# Levy Nuclear Plant

USACE/EPA/NRC Meeting  
07-14-11

# Preferred Blowdown Pipeline Route

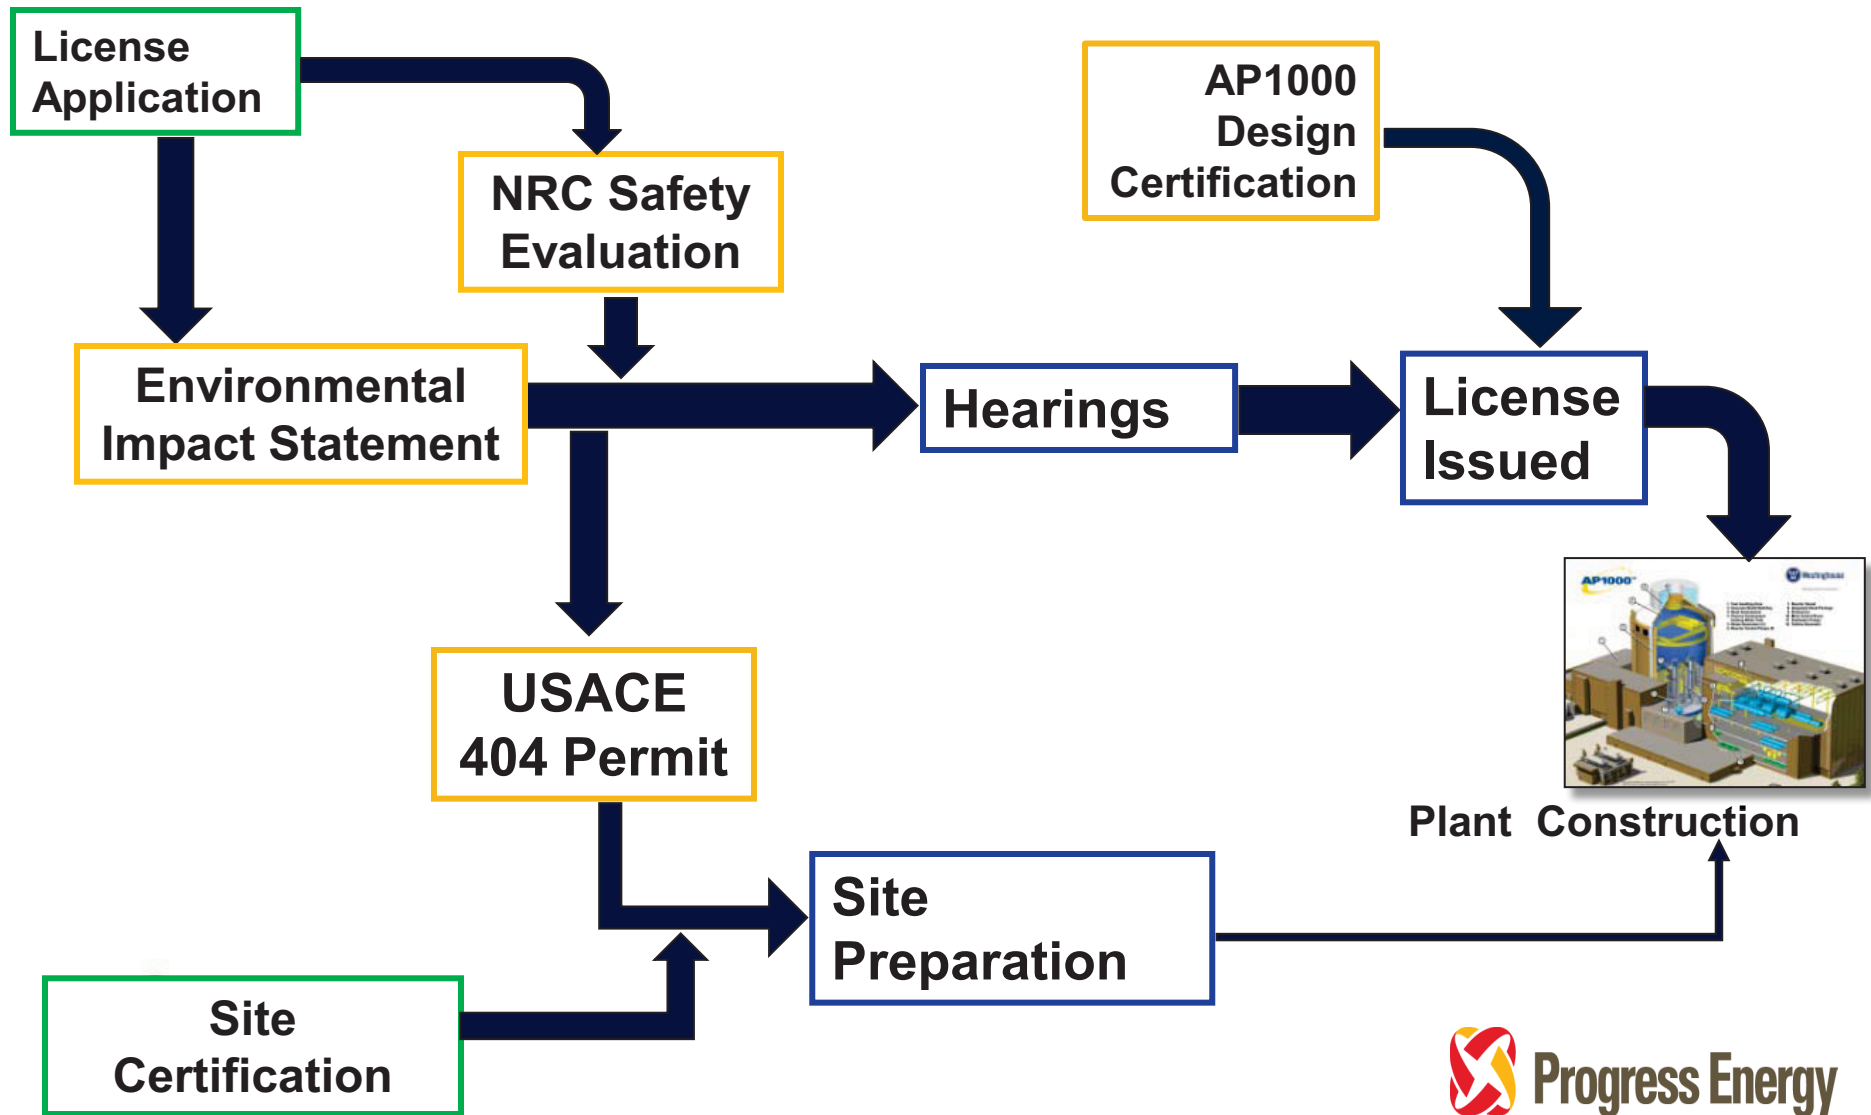
8. EPA concurs that an alternative blowdown pipeline route should be established to avoid impacts to 4.5 acres of salt marsh wetland.

2. On January 3, 2011, the Corps approved a Jurisdictional Determination for an alternate blowdown pipeline route that does not transverse tidal wetlands, However, it appears that the Corps has no written record that PEF has formally modified the blowdown route.

PEF modified the blowdown pipeline corridor to allow the pipeline to avoid any salt marsh wetland impact in Mod C to the Site Certification approved by FDEP on 01/25/11.

PEF modified the blowdown pipeline corridor to allow the pipeline to avoid any salt marsh wetland impact in Mod C to the Site Certification approved by FDEP on 01/25/11. PEF will provide a map/drawing of the revised route in our response by November 2011.
